# Nomad

# SERVICE BULLETIN

## NEW AIRSPEED LABEL (MODIFICATION N435)

Figure 1 Location Of Airspeed Label

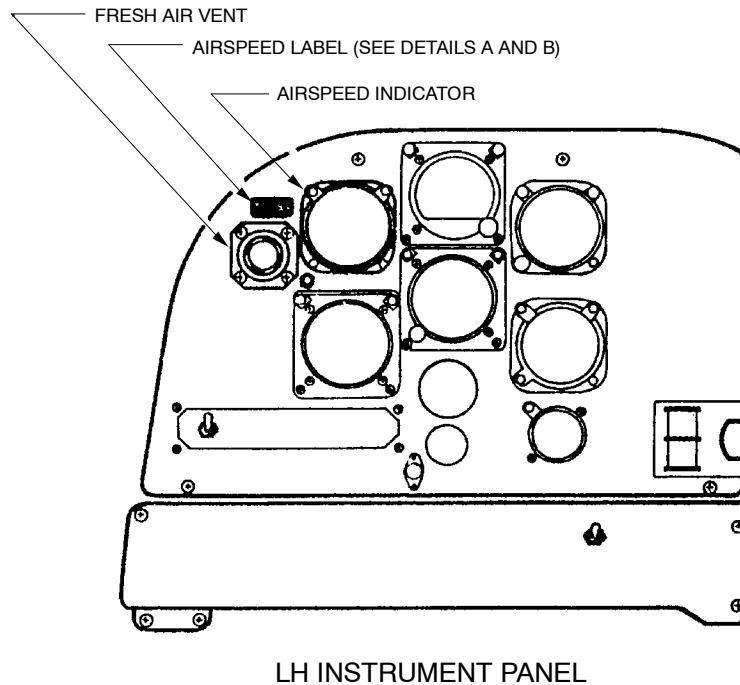
The Va Design Manoeuvre Speed is incorrectly stated on the, label adjacent to the Airspeed Indicator. The correct  $V_A$  Design Manoeuvre Speed is 136 kt.

Label PN 1/N-80-309 is removed and replaced by label PN I/N-80-538.

- A. Remove label PN 1/N-80-309 from the LH. Instrument Panel (Ref Figure 1, Detail A).
- B. Clean any residual adhesive from the LH. Instrument Panel by rubbing with a cloth dampened with methylated spirit (methanol).
- C. Attach adhesive label PN 1N-80-538 to the LH. Instrument Panel (Ref Figure 1, Detail B).

Prior to receipt of Label PN 1/N-80-538, operators may locally manufacture a temporary label in accordance with Figure 1, Detail B.
